UNITED STATES PATENT AND TRADEMARK OFFICE

| APPLICATION NO. | FILING DATE | FIRST NAMED INVENTOR | ATTORNEY DOCKET NO. | CONFIRMATION NO. |
|-----------------|-------------|----------------------|---------------------|------------------|
| 09/841,094      | 04/25/2001  | Rudolf Seiz          | Q63688              | 4971             |

**Office Action Summary**

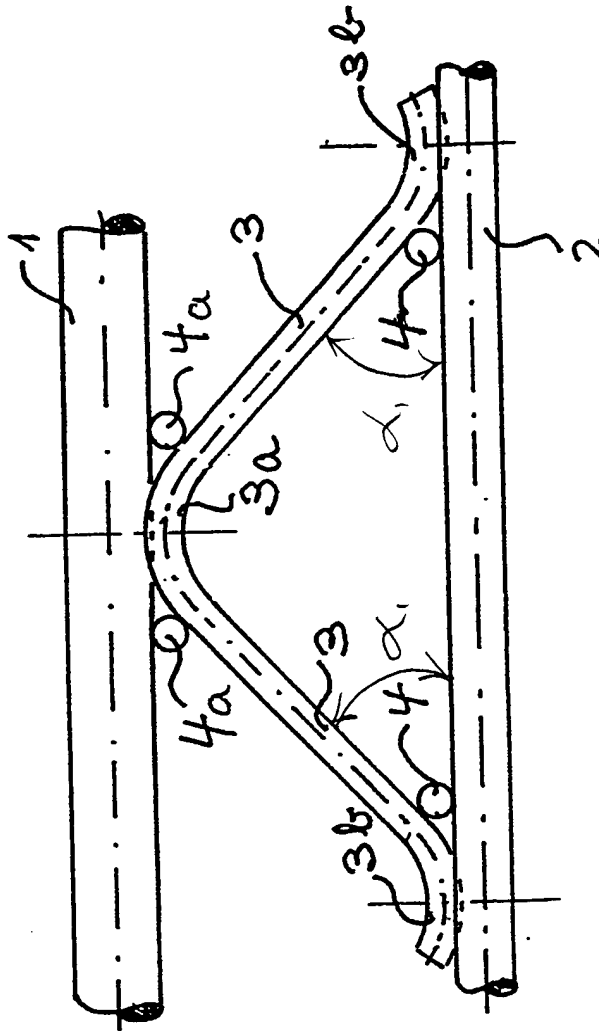
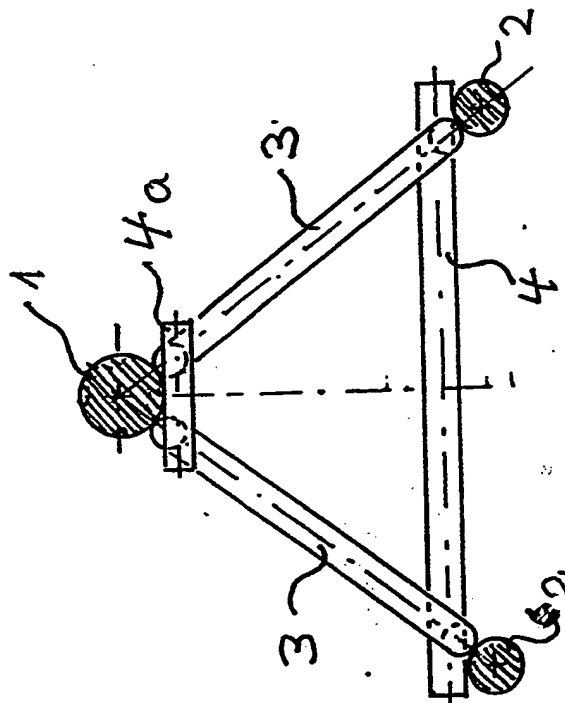
*Truss does not attach to lower boom with a curved or bent portion.*

1. The specification is objected to as failing to provide proper antecedent basis for the claimed subject matter. See 37 CFR 1.75(d)(1) and MPEP § 608.01(o). Correction of the following is required: The specification does not clearly detail what is meant by attaching the truss members to the lower boom members “without bending”. Is without bending referring to the truss braces themselves not being bent or the truss braces not bending about the boom members. Clearly, the truss braces are bent as at curve (3b). Clarification is required.

Further, it is not clear how the truss members are attached “without bending” when it is detailed that each truss member have a curved part and a straight part. The curved part is a clear indication of “bending”. Clarification is required.

In regards to the applicant's argument that the truss members of DE 19111627 are not attached to the boom members without bending, the step of bending is a method step. The method of forming a device is not germane to the issue of patentability of the device itself. Thus, the step of attaching without bending has not been given patentable weight. Further, it is not clear what applicant intends by "attachment without bending". Is "attachment without bending" referring to the truss braces themselves or the to the truss braces about the lower boom. It is clear from the drawings and the specification that the truss members each have a curved portion (3b). Surely, this is a bend. Thus, there must be some type of bending.
